Staff Report

To: Salt Lake City Planning Commission
From: Casey Stewart; 801-535-6260
Date: April 22, 2021 (for April 28, 2021 hearing)
Re: **PLNPCM2020-00862** Conditional Use for **7-Eleven Gas Station Rebuild**
PLNPCM2020-00956 Design Review for **7-Eleven Gas Station Rebuild**

CONDITIONAL USE & DESIGN REVIEW

PROPERTY ADDRESS: 1690 South 900 West
PARCEL ID: 15-14-253-051, 15-14-253-041
MASTER PLAN: Westside Master Plan
ZONING DISTRICT: CB (Community Business)

PROPOSED SITE EXHIBIT

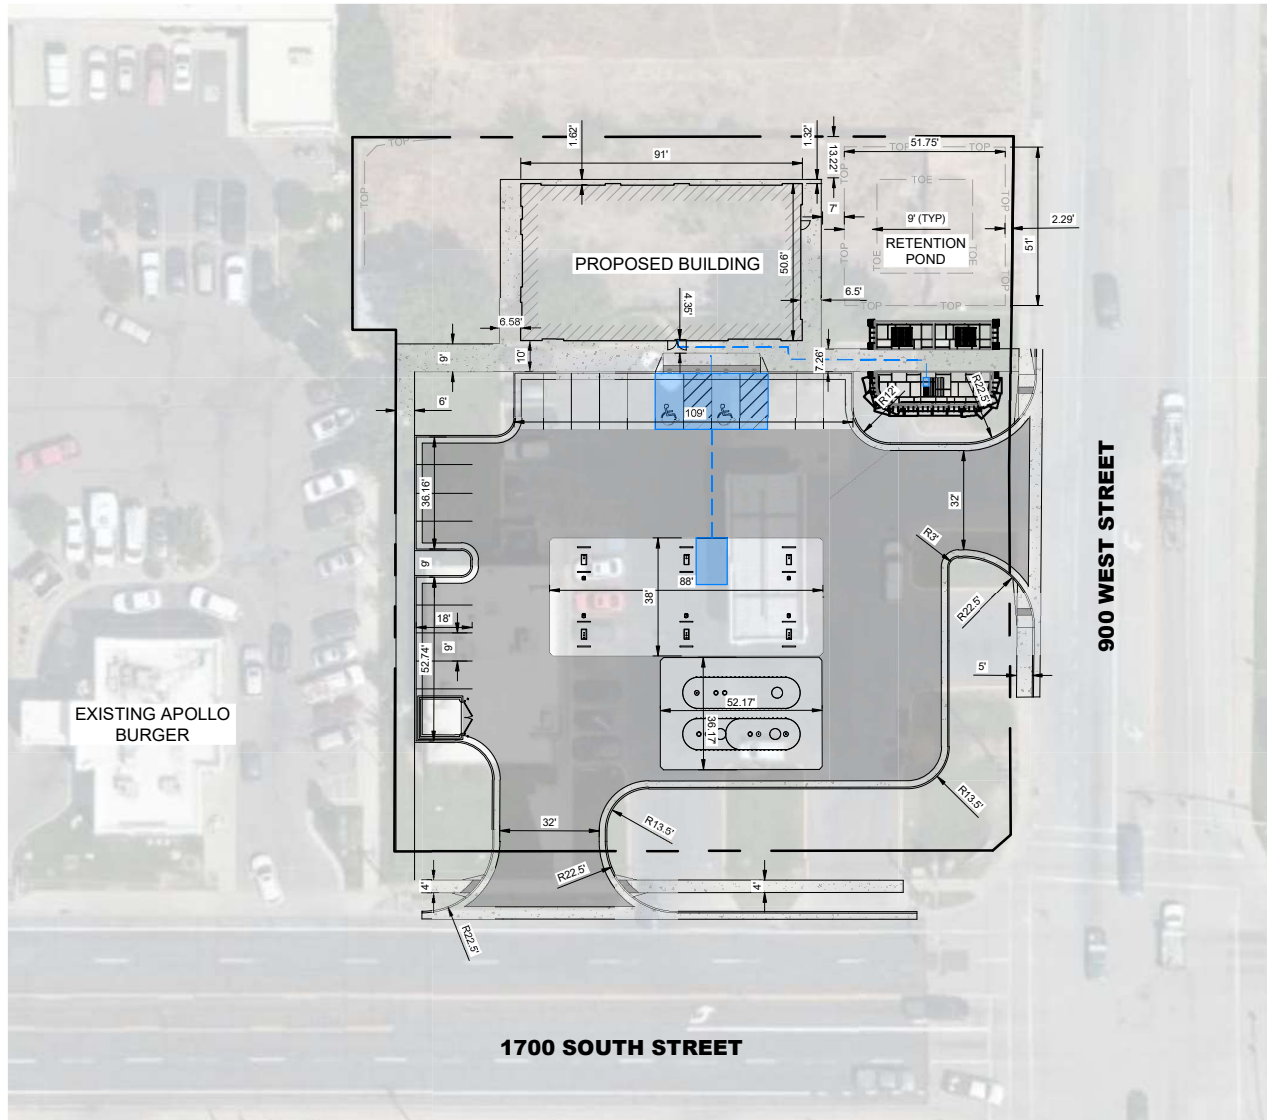
Modification to maximum setback: Through the design review process, the applicant is requesting modification to the 15-foot maximum setback of the CB zoning district, which stipulates that at least 75% of the building façade be located within 15 feet of the property line. The proposed building is located 70 feet from the front property line. This location is to accommodate an on-site detention basin for stormwater management, which is located between the front property line and the building.

To mitigate this distance discrepancy and facilitate pedestrian access and engagement, the applicant proposes a concrete sidewalk and gathering space directly from the public sidewalk along 900 West to the building main entrance. The gathering space includes multiple benches and tables near the sidewalk for use of customers and the general public.

The proposed building is oriented toward the centrally located parking area and gas pumps for the ease of their primary customers, which predominantly arrive in vehicles. This orientation works well for the nature of the business and is typical of suburban gas stations. However, the orientation does not satisfy the design review standard that buildings be oriented to the public sidewalk (21A.59.060.B). The building's main entrance is oriented to the parking area and gas pumps and at such a distance into the property that it does not strictly meet this design standard.

Staff's recommendation to deny the design review petition is based on the building location not strictly meeting the design review standard. The following points, although not expressly stated in the design review standards, are provided for consideration:

01 SIDE (EAST) ELEVATION
1/4" = 1'-0"

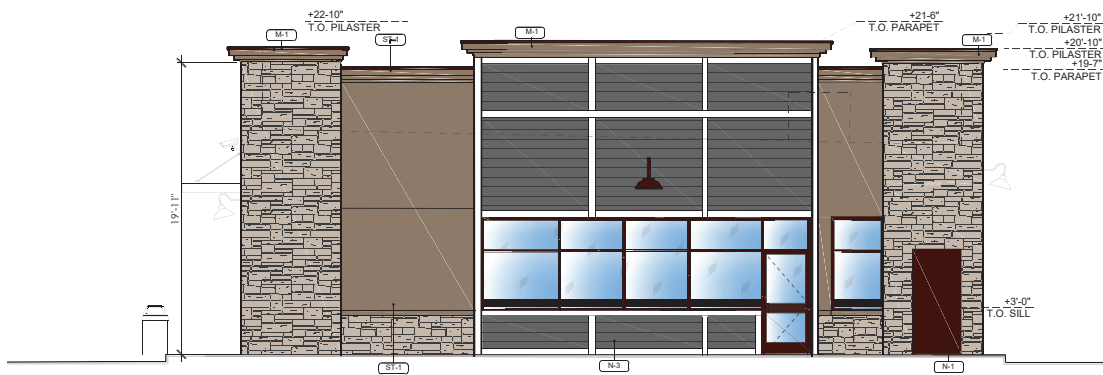
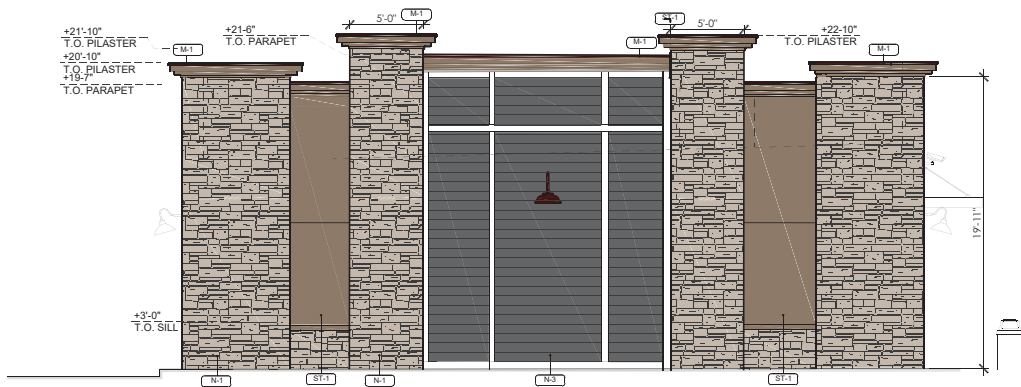
1. Locate active ground floor uses at or near the public sidewalk.
2. Maximize transparency of ground floor facades.
3. Use or reinterpret traditional storefront elements like sign bands, clerestory glazing, articulation, and architectural detail at window transitions.
4. Locate outdoor dining patios, courtyards, plazas, habitable landscaped yards, and open spaces so that they have a direct visual connection to the street and outdoor spaces.
